# Architect's Supplemental Instructions

Police Department Midtown District

ASI Number 004

1/25/2018

**ROOF FRAMING  
PLAN**

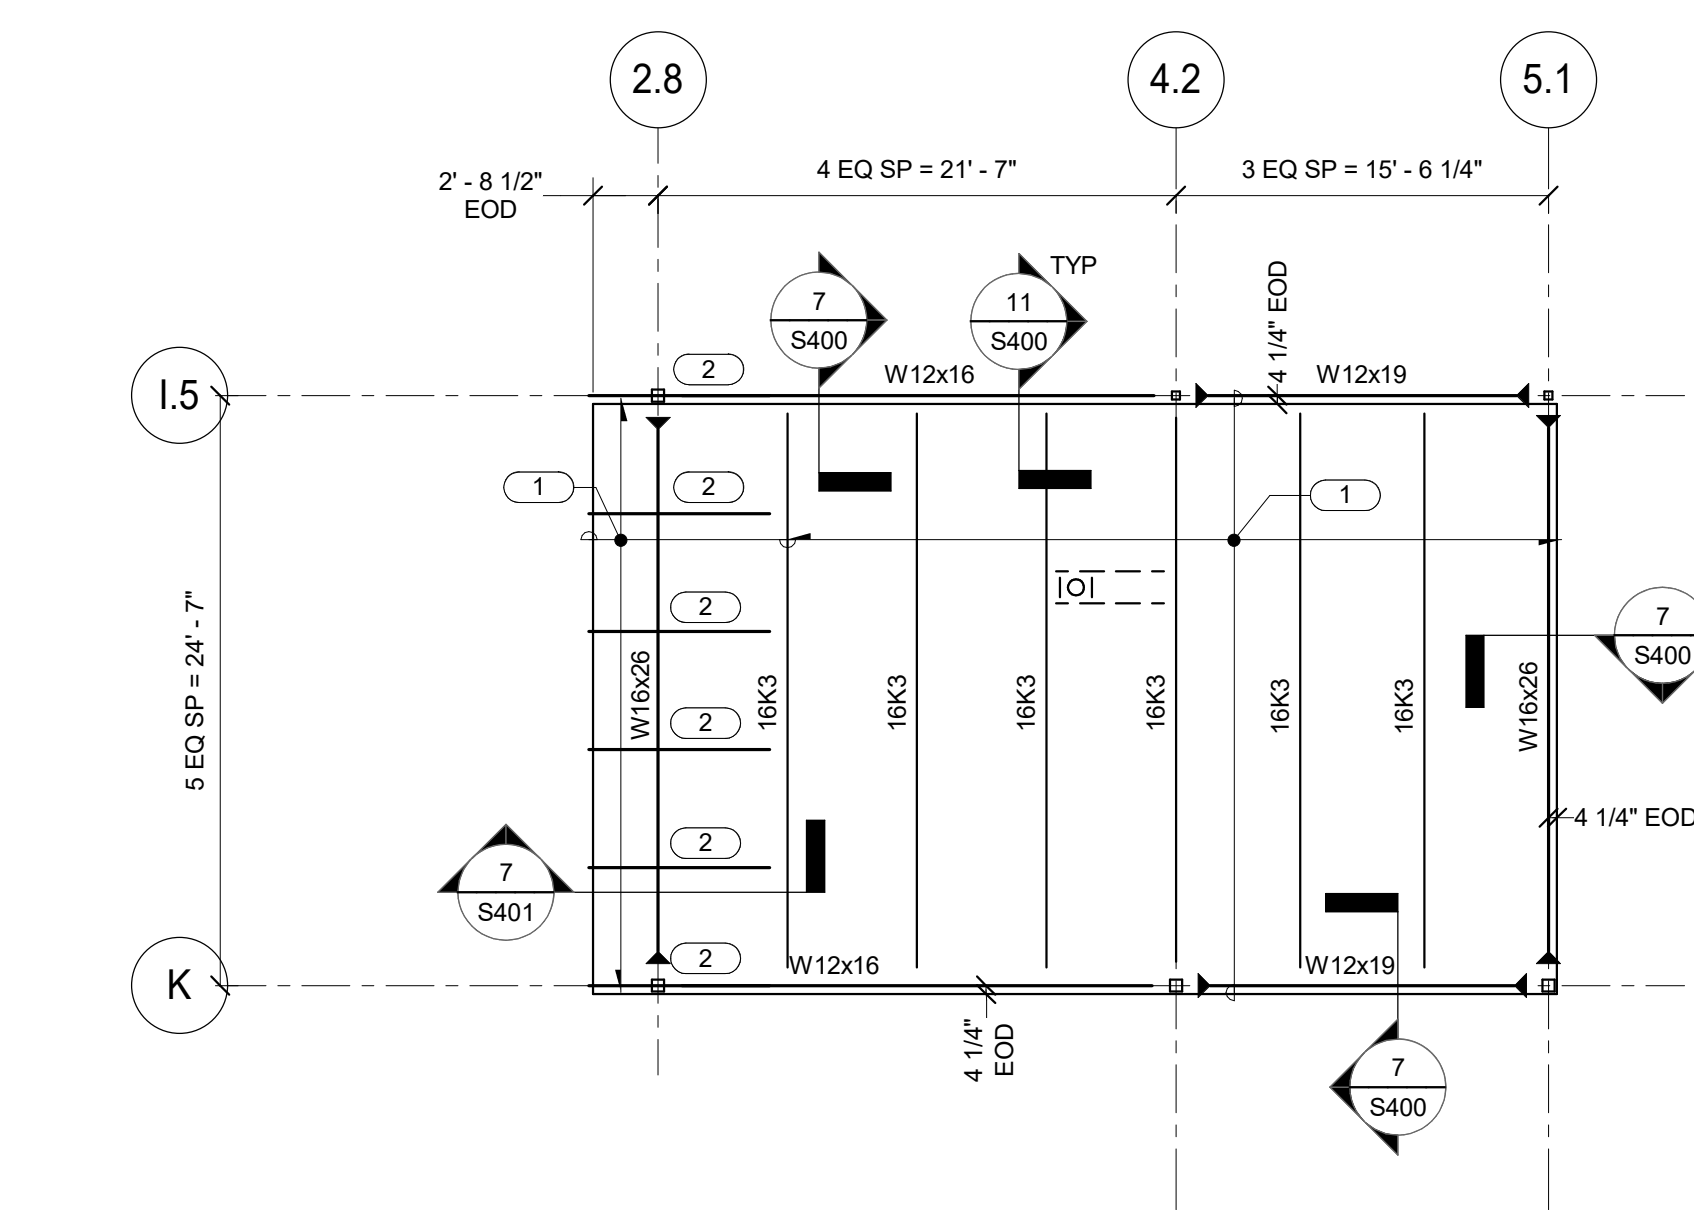
5. The attached sheet S102 has been issued with the following revisions:
  - A. Detail 2/S102 ADD deck support angle to clerestory framing along Grid H - refer to detail 4
  - B. Detail 1/S102 ADD angle to steel column to support light gage header at Column J-6 as addressed in RFI 020.
  - C. Detail 1/S102 ADD HSS 10x6 structural header over Storefront M attached to building columns for support of stud wall above as addressed in RFI 020

KEYNOTE 4: L6x3 1/2x5/16 x 0'-8" ANGLE FIELD WELDED WITH 1/4" FILLET WELDS TOP AND BOTTOM TO SOUTH FACE (OR EAST FACE AT CONTRACTOR'S OPTION) OF COLUMN TO SUPPORT LIGHT GAGE HEADER. COORDINATE ELEVATION WITH LIGHT STUD CONTRACTOR.

**Site Demolition and  
Erosion Control Plan**

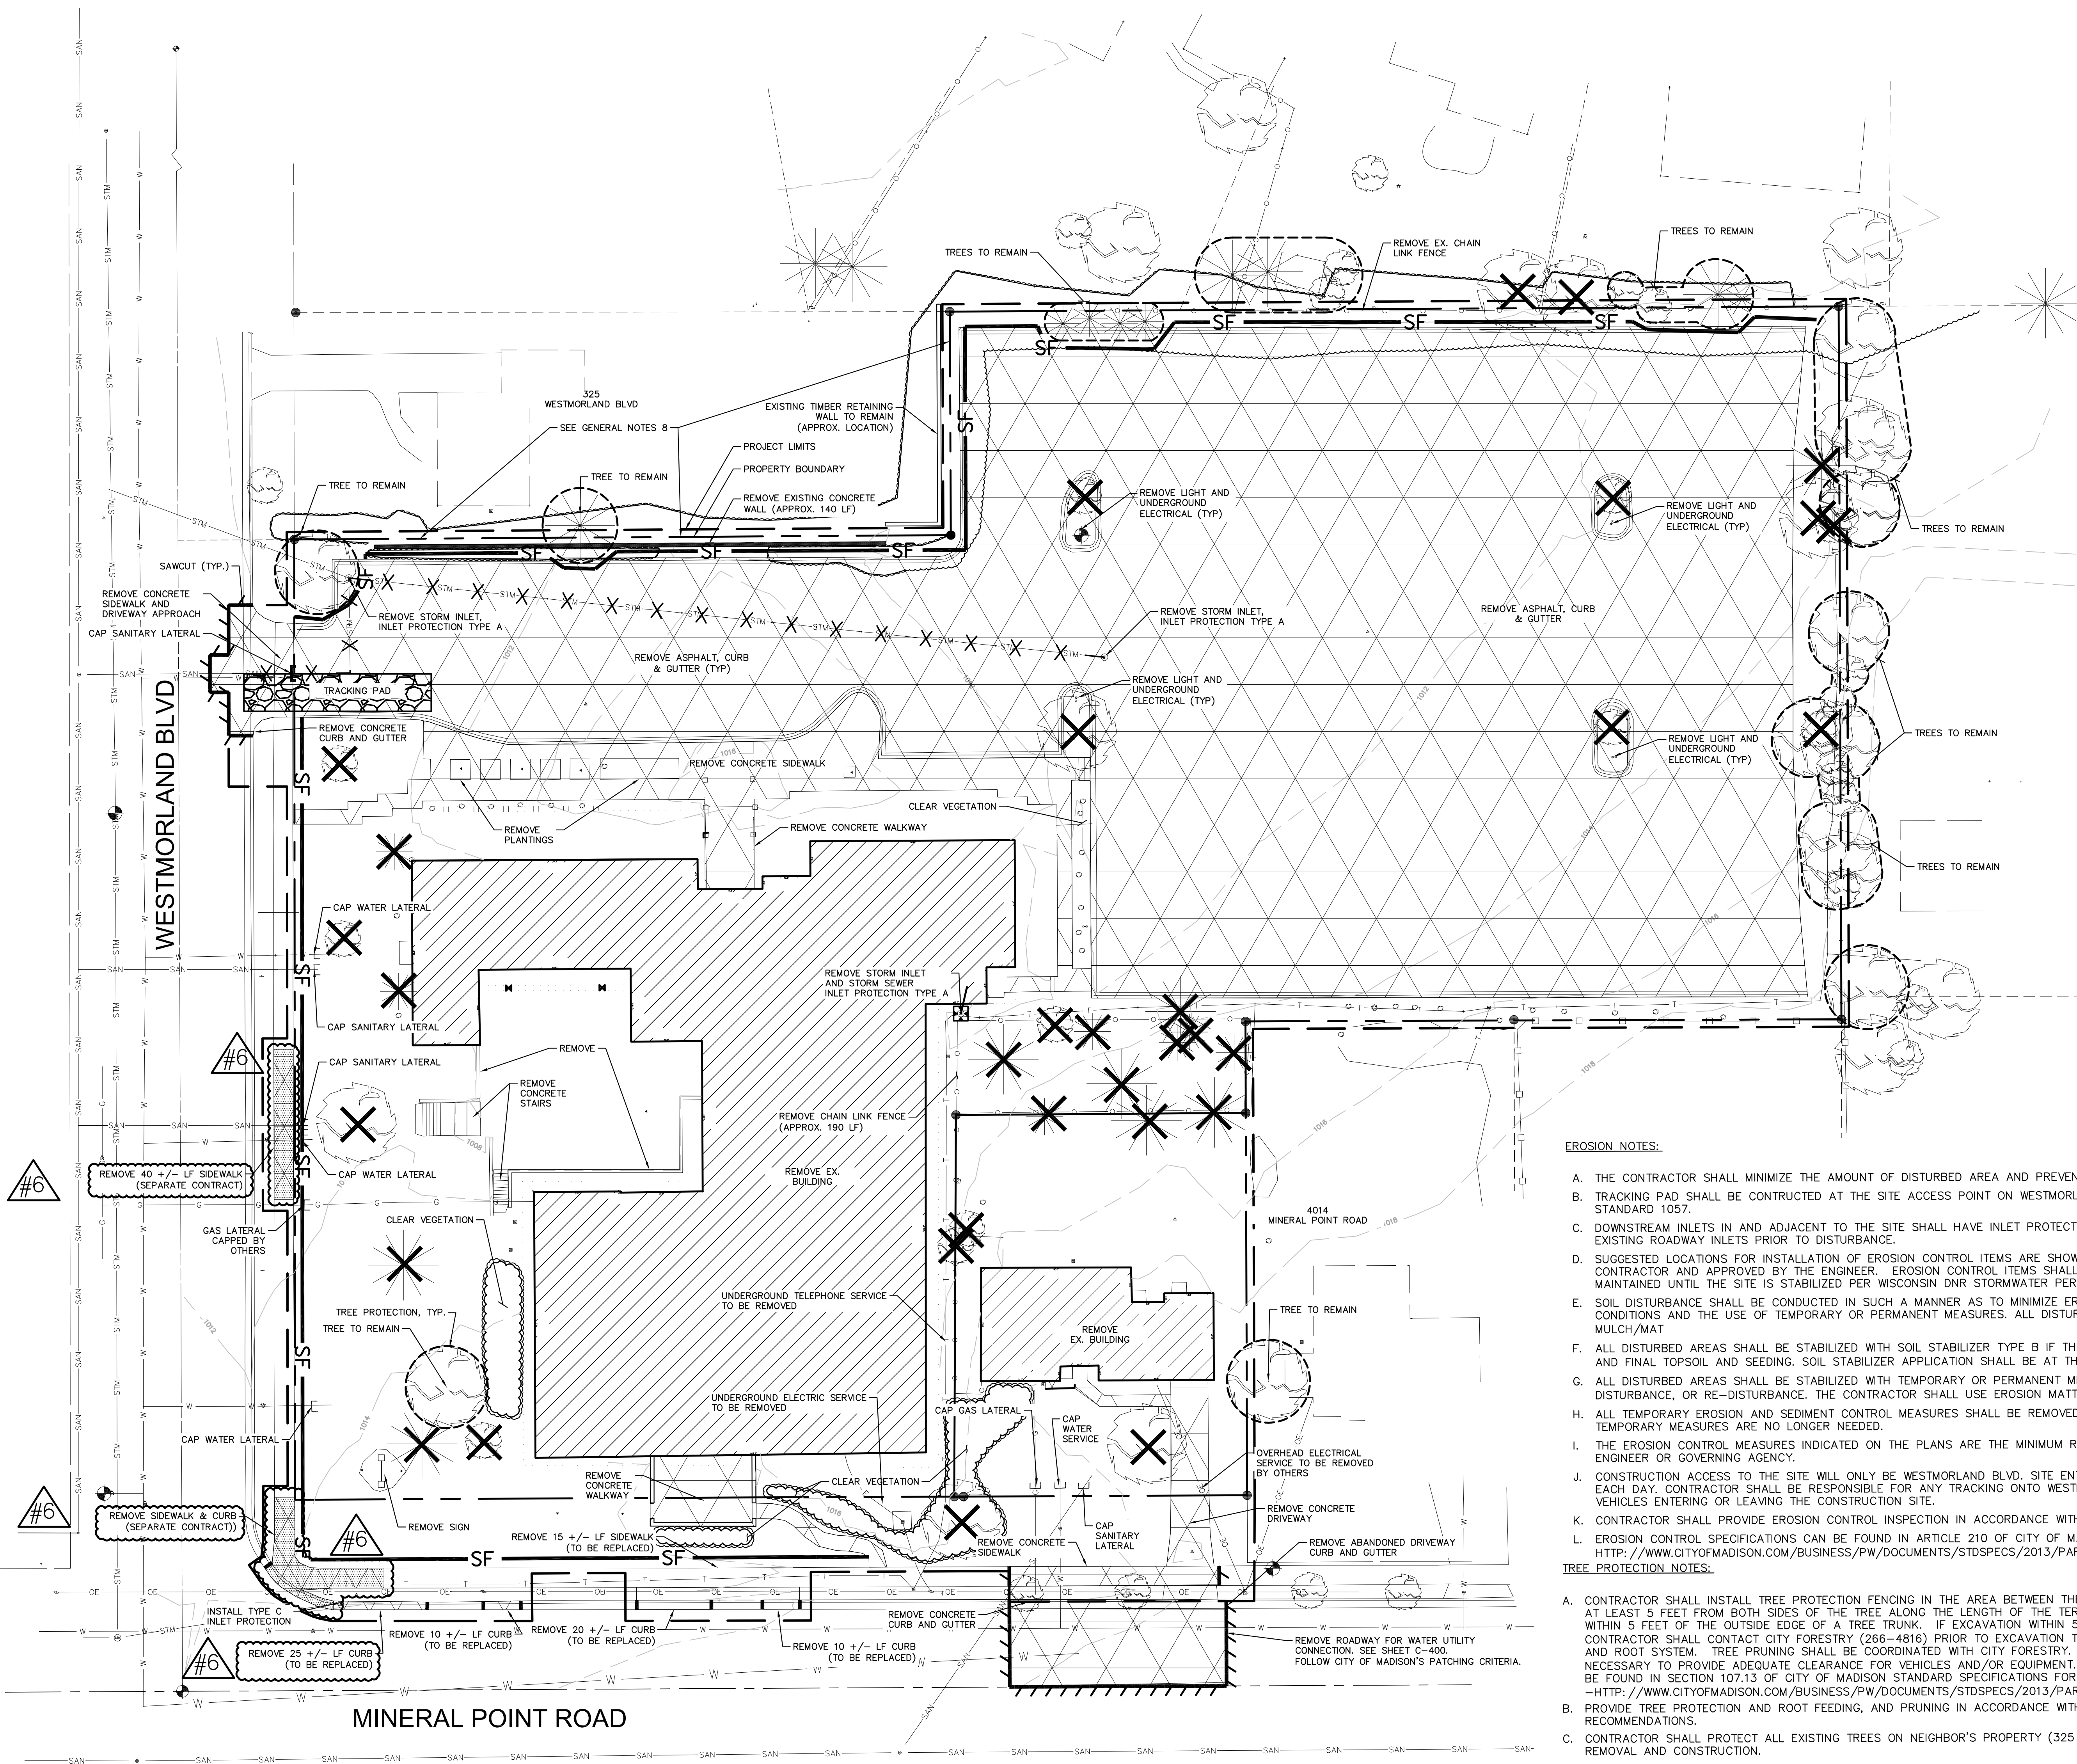
6. The attached sheet C100 has been reissued with the following revisions:
  - A. Existing concrete sidewalks and curbs have been shown removed from the project. This information is documentation that was previously issued in CB-4
